# WATER QUALITY MEMORANDUM Utah Coal Regulatory Program

SUBJECT: 2009 4th Quarter Water Monitoring: Bear Canyon Mine, C/015/0025,  
Task ID # 3423

TDS Concentrations at Stream Sample Location BC-3

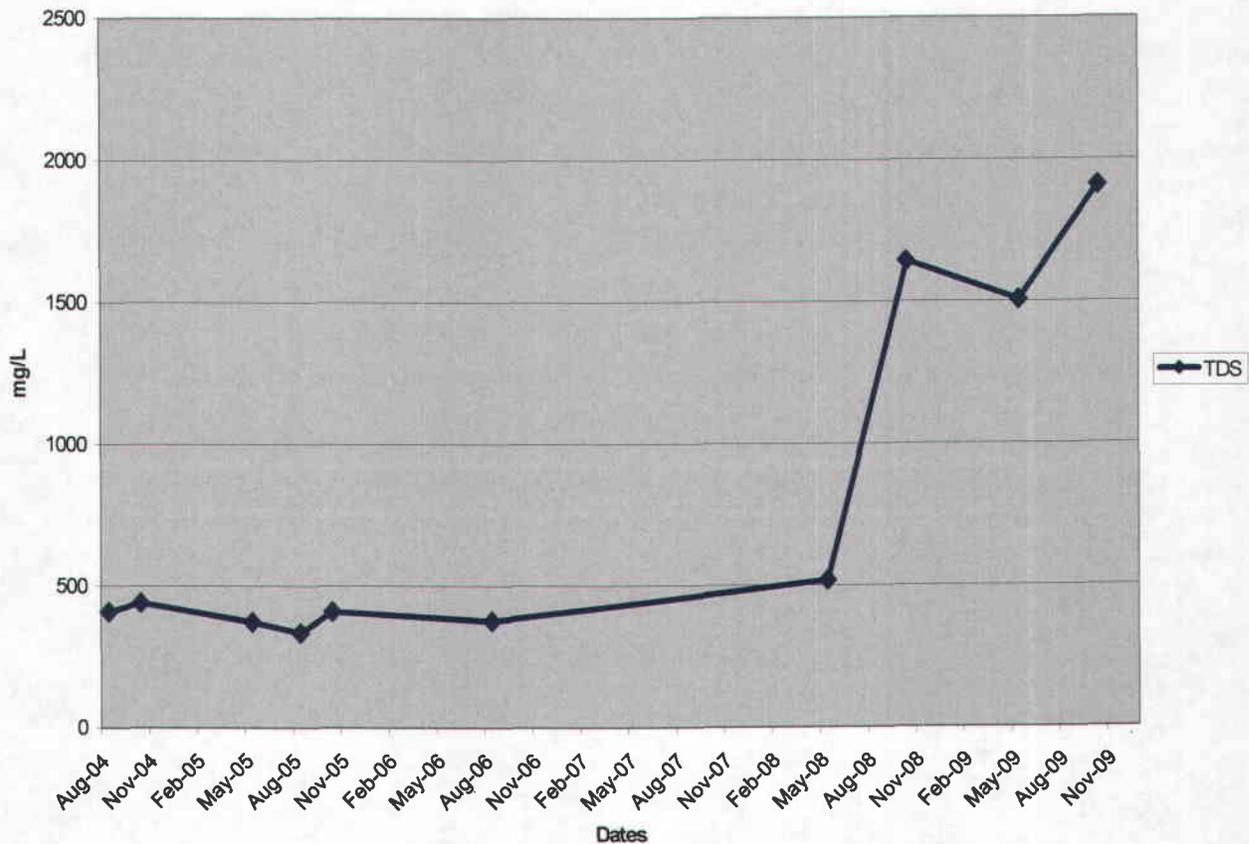
Sample BC-3 at the Lower Right Fork of Bear Creek has shown a recent increase in the levels of Total Dissolved Solids (TDS) since May 2008 (see chart shown below). Prior to this increase, TDS levels have averaged around 400 mg/L since 2004. State water quality standards for the Bear Creek stream reach for TDS is 4,800 mg/L. The most recent data result for TDS from BC-3 showed TDS at a concentration of 1,909 mg/L. The sampling plan as currently written only specifies the collection of operational parameters during the months of February, August, and October and field parameters during the months of July and September.

- Sample BC-3 at the Lower Right Fork of Bear Creek has shown a recent increase in the levels of Total Dissolved Solids (TDS) since May 2008. This indicates that excess sediment may be discharging into the creek. The operator should evaluate sediment controls in this area and determine if there is any mitigation needed to control the level of sediment entering the water body. The location of stream sample BC-3 is an important one due to the fact that it is located adjacent to the main road. A high likelihood of this area receiving sediment from the disturbed area exists. Therefore, the Division recommends that Permittee modify the water monitoring plan to sample this location for operational parameters whenever flow is present. Currently, the water monitoring plan only requires the location be sampled for operational parameters during the months of February, August, and October.
